To: Kristopher Byrd, Well Construction and Compliance Section Manager
From: Travis Kelly, Well Construction Compliance Coordinator
Subject: Review of Water Right Application G-19051
Date: January 6, 2022

Application # G- 19051

WATER RESOURCES DEPARTMENT**MEMO****11/18/2021****TO: Application G- 19051****FROM: GW: M. Thoma**
(Reviewer's Name)**SUBJECT: Scenic Waterway Interference & General/Local Surface Water Evaluation for Deschutes Ground Water Study Area**

Well Location Map

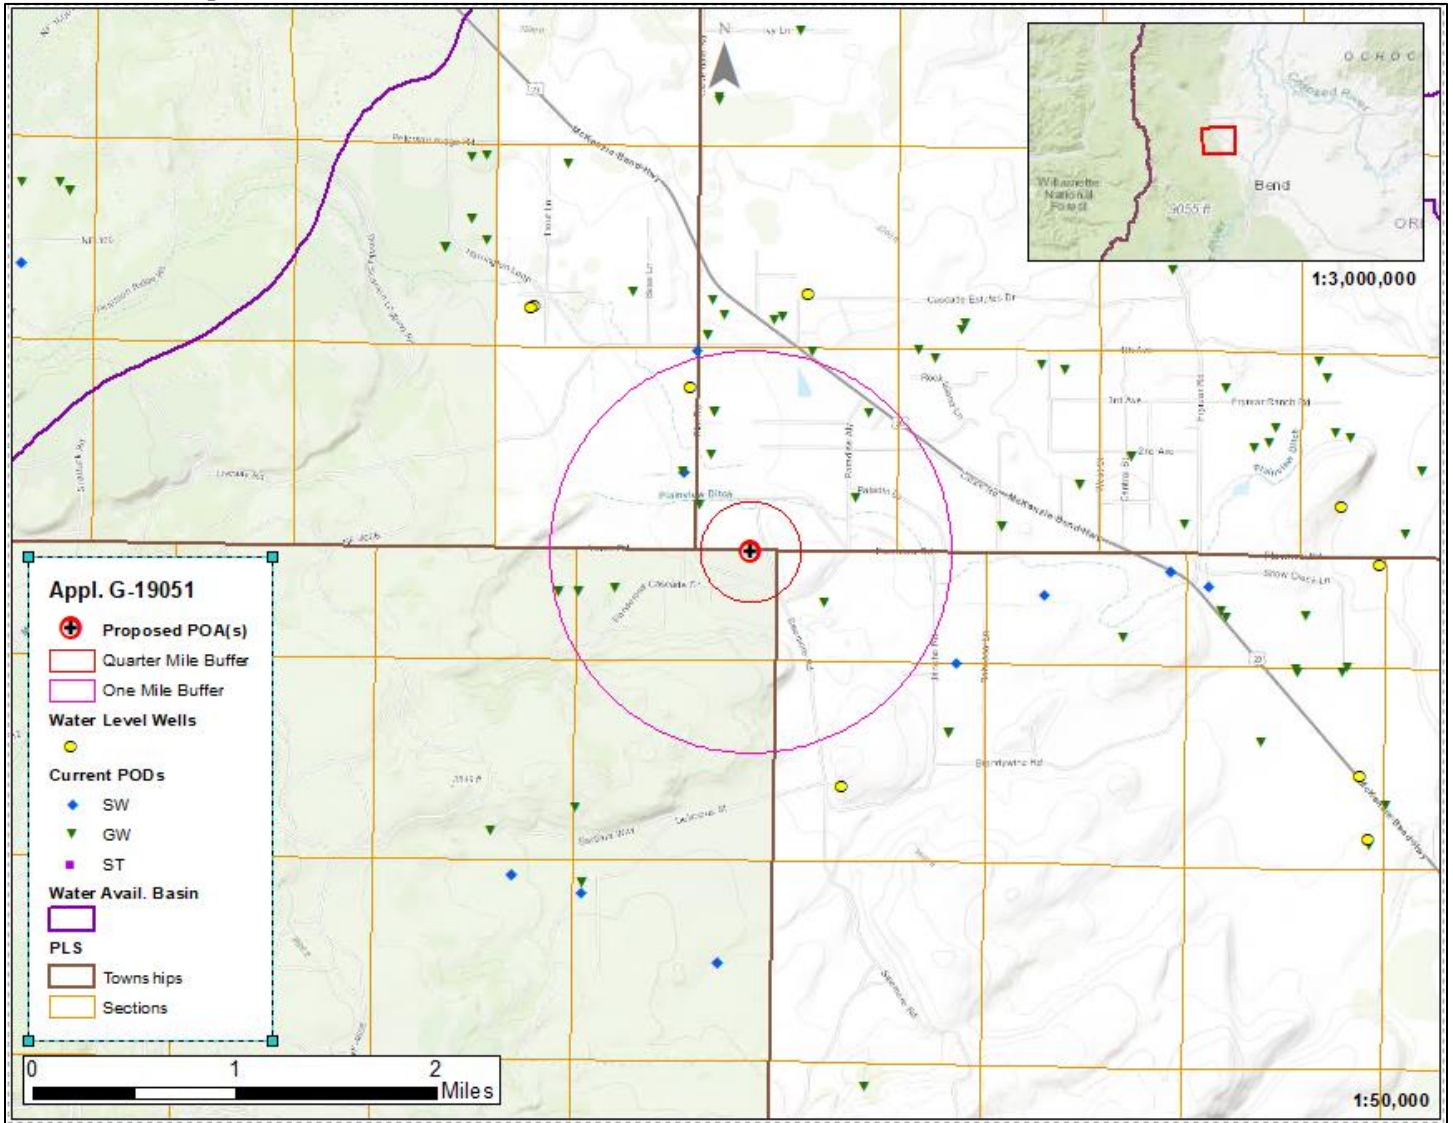
A4. Comments: *A new well (DESC 62485 - attached) has been drilled on the taxlot and very near the proposed location of the POD in February, 2021. This review assumes that this new well was drilled for this permit. If it is not intended to be used for this permit, the location and depth provide excellent estimates for the above table.
